MECKLENBURG COUNTY
DEPARTMENT OF ENVIRONMENTAL HEALTH

Application for an
Installation, Construction, Alteration, and/or Repair Permit
(Individual Septic Tank System with Subsurface, Soil Absorption, Effluent Discharge)

SITE EVALUATION

RE: Property located at 1501 Sunset Road
Dear Mr. Burchell:

**See Diagram on Back (includes: soil areas, property lines, roads, streams, gullies, wet areas, fill areas, wells, water bodies, slopes)

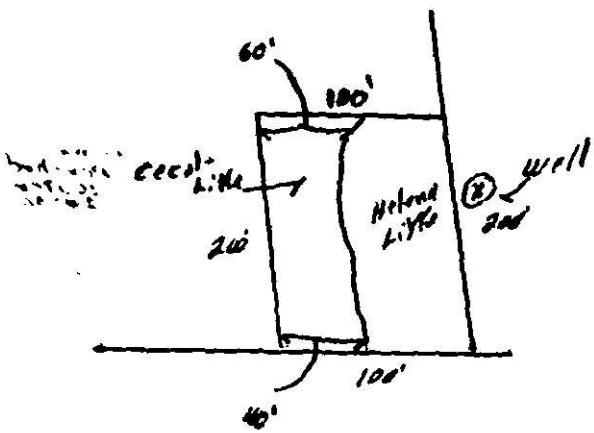
FACTORS	AREA 1	AREA 2	AREA 3	AREA 4
1. SLOPE (%)	S / PS 2-8% / U	S / PS 2-8% / U	S / PS / U	S / PS / U
2. SOIL TEXTURE (12-36 inches) Sandy, Loamy, Clayey (Note 2-1 Clay)	S / PS Clay / U	S / PS 2-1 Clay / U	S / PS / U	S / PS / U
3. SOIL STRUCTURE (12-36 inches)	S / PS Blocky / U	S / PS Blocky / U	S / PS / U	S / PS / U
4. SOIL DEPTH (inches)	S / PS 36-40" / U	S / PS 24-30" / U	S / PS / U	S / PS / U
5. RESTRICTIVE HORIZONS (Inches) (Impervious strata, Rock)	S / PS >36" / U	S / PS saprolite 24-36" / U	S / PS / U	S / PS / U
6. SOIL DRAINAGE/GROUNDWATER (external and internal)	S / PS >36" to ground water / U	S / PS perched water 24-36" / U	S / PS / U	S / PS / U
7. OTHER (Specify)	S / PS see Note / U	S / PS / U	S / PS / U	S / PS / U
8. SOIL GROUP	IVA	IVA		
9. SITE CLASSIFICATION	Provisionally suitable	unsuitable		
10. SOIL SERIES	Cecil-Like	Helena-Like

Recommendations/Comments: Limited area - Recommend plans be submitted for house, system & well locations.

At your request, a field investigation was conducted on the property designated above. The soils on the property were found to contain a limited area of provisionally suitable soil for the installation of a ground absorption sewage disposal system. A copy of the site evaluation report is enclosed for your information.

Should you desire to file for permission to install a ground absorption sewage disposal system, please submit plot plans for the proposed construction, well, and ground absorption sewage disposal system to this office. They will be reviewed and if it is found that there is an adequate area of provisionally suitable soil to accommodate the proposed installation, an Improvements Permit will be issued by this office.

**See Diagram on Back (includes: soil areas, property lines, roads, streams, gullies, wet areas, fill areas, wells, water bodies, slopes)

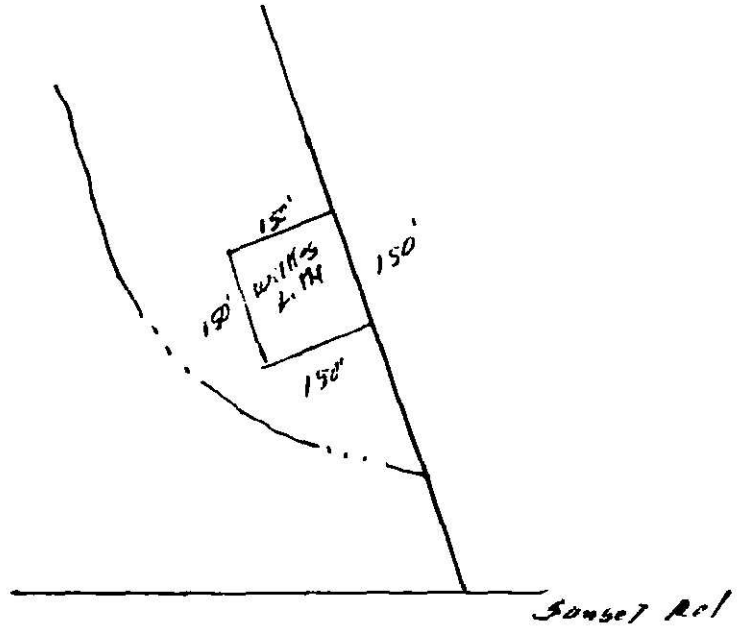
FACTORS	AREA 1	AREA 2	AREA 3	AREA 4
1. SLOPE (%)	S (PS) 10-20% U	S PS U	S PS U	S PS U
2. SOIL TEXTURE (12-36 inches) Sandy, Loamy, Clayey (Note 2-1 Clay)	S PS 2-1 Clay (U)	S PS U	S PS U	S PS U
3. SOIL STRUCTURE (12-36 inches)	S (PS) Weak Block U	S PS U	S PS U	S PS U
4. SOIL DEPTH (inches)	S PS 6-13" (U)	S PS U	S PS U	S PS U
5. RESTRICTIVE HORIZONS (Inches) (Impervious strata, Rock)	S PS <30" to saprolite (U)	S PS U	S PS U	S PS U
6. SOIL DRAINAGE/GROUNDWATER (external and internal)	S (PS) >30" to groundwater U	S PS U	S PS U	S PS U
7. OTHER (Specify)	S PS U	S PS U	S PS U	S PS U

8. SOIL GROUP 10B

9. SITE CLASSIFICATION unsuitable

10. SOIL SERIES Wilkes-Like

At your request, a field investigation was conducted on the property designated above and was classified unsuitable for the installation of a ground absorption sewage disposal system. A copy of the site evaluation report is enclosed for your information.

Sites classified as unsuitable may be utilized for soil absorption disposal systems provided engineering, hydrogeologic, soil and environmental studies indicate that a suitable septic tank system or a suitable alternate system can be reasonably expected to function satisfactorily.

Should you desire to file for permission to install an alternate system, plans and specifications prepared by a person with a demonstrated knowledge of ground absorption sewage treatment disposal systems, soil and rock characteristics, groundwater hydrology and drainage systems should be submitted to this office. They will be reviewed and if it is found that the system may be reasonably expected to function satisfactorily, approval will be given upon the execution by you of "Septic Tank Agreemnt Form" provided by this office.
